Executive Director's Recommendation

Commission Meeting: October 1, 2020

PROJECT Korean War Veterans Memorial Wall of Remembrance Graphics Package National Mall Independence Avenue and Daniel French Drive, SW Washington, DC	NCPC FILE NUMBER 8107
SUBMITTED BY United States Department of the Interior National Park Service	NCPC MAP FILE NUMBER 1.71(73.10)45196
REVIEW AUTHORITY Commemorative Works per 40 U.S.C. § 8905	APPLICANT'S REQUEST Approval of final site development plans
	PROPOSED ACTION Approve final site development plans with comments
	ACTION ITEM TYPE Consent Calendar

Korean War Veterans Memorial Wall of Remembrance - Graphics Package

Updated UN curb and WoR panels

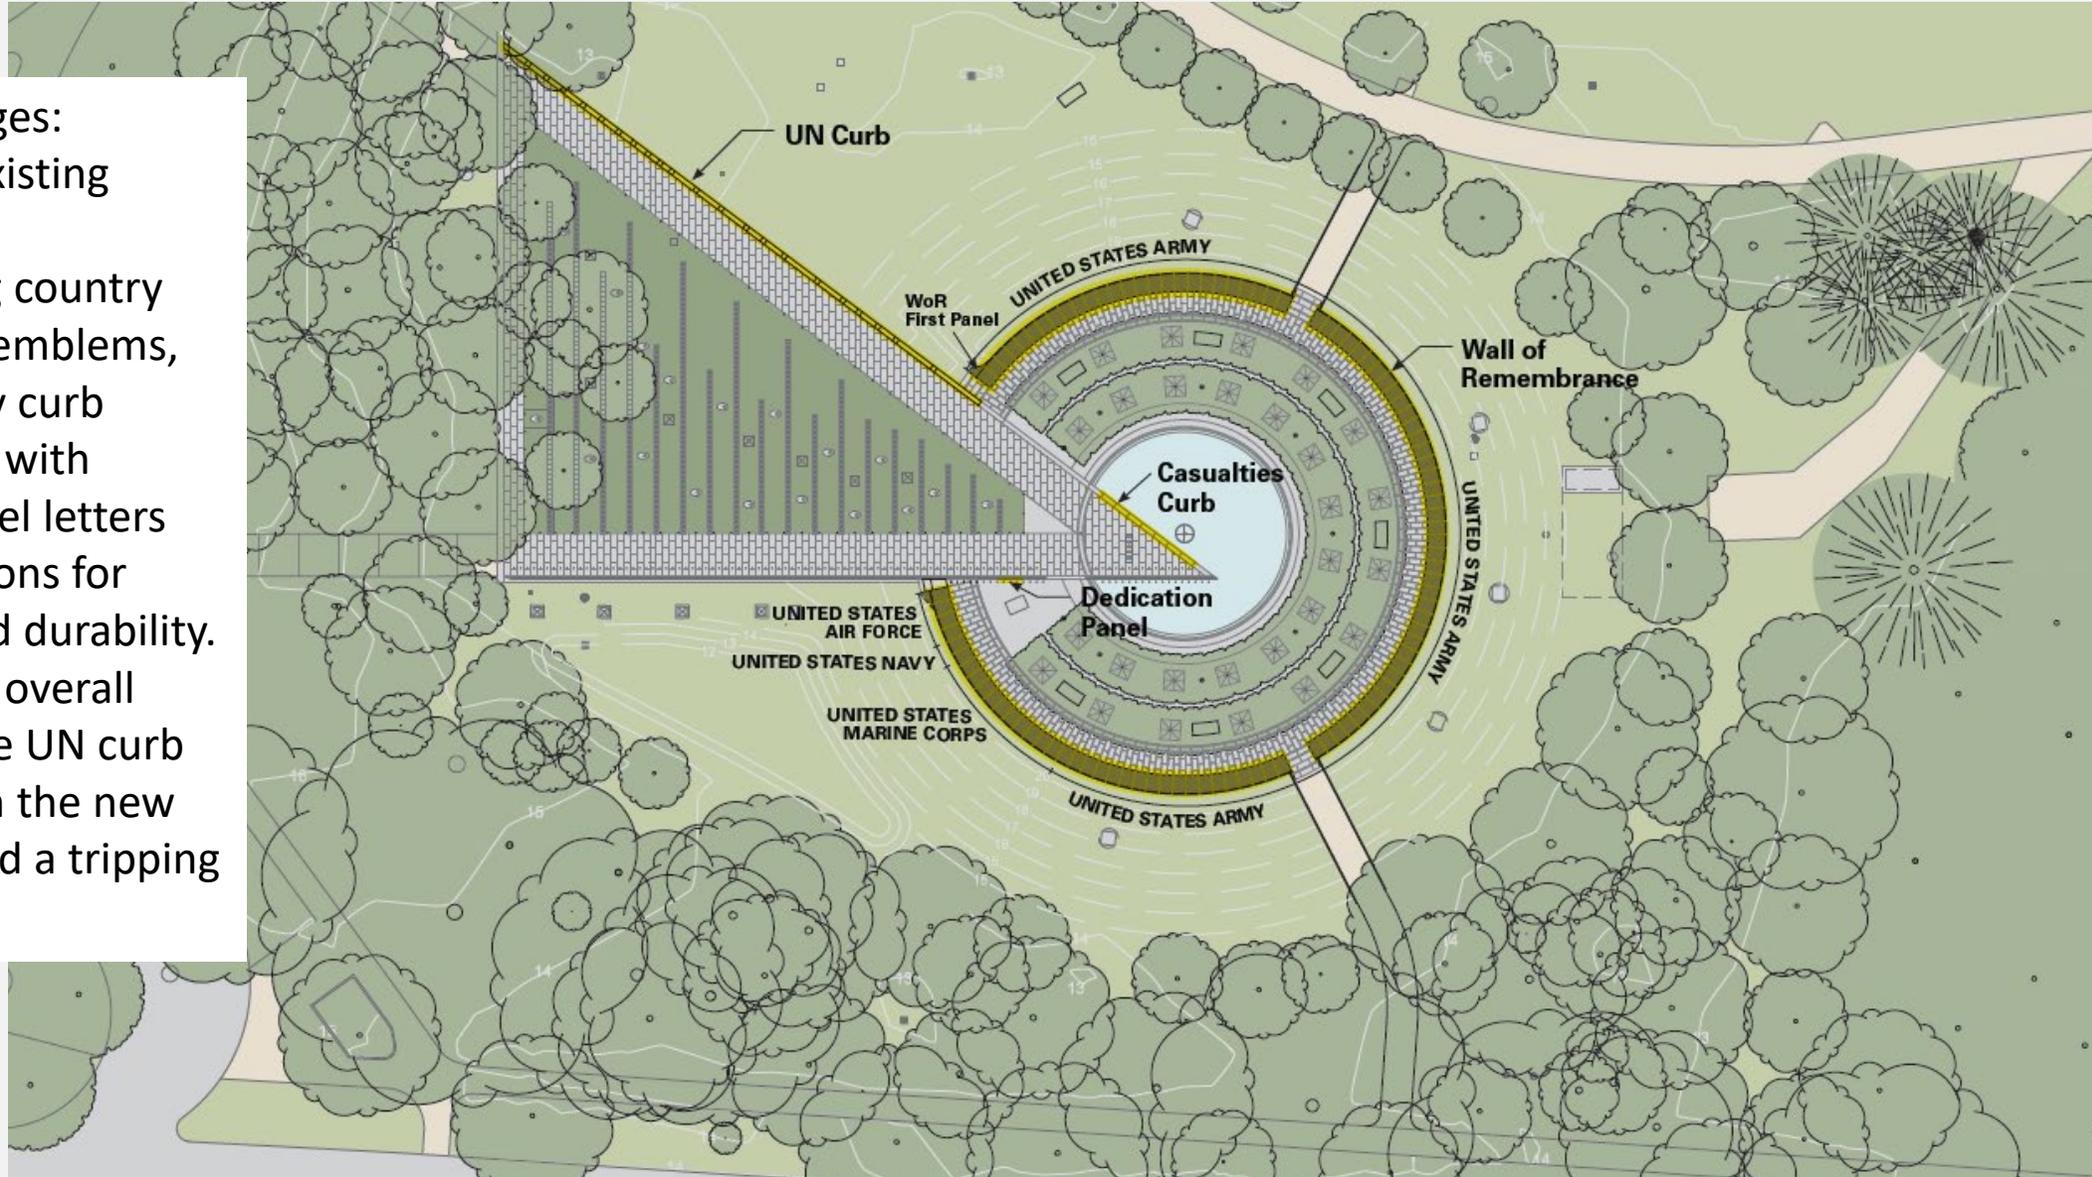
Proposed Changes:

1. Replacing existing sandblasted contributing country names, UN emblems, and casualty curb information with stainless steel letters and medallions for legibility and durability.
2. Shorten the overall length of the UN curb to align with the new WoR to avoid a tripping hazard.
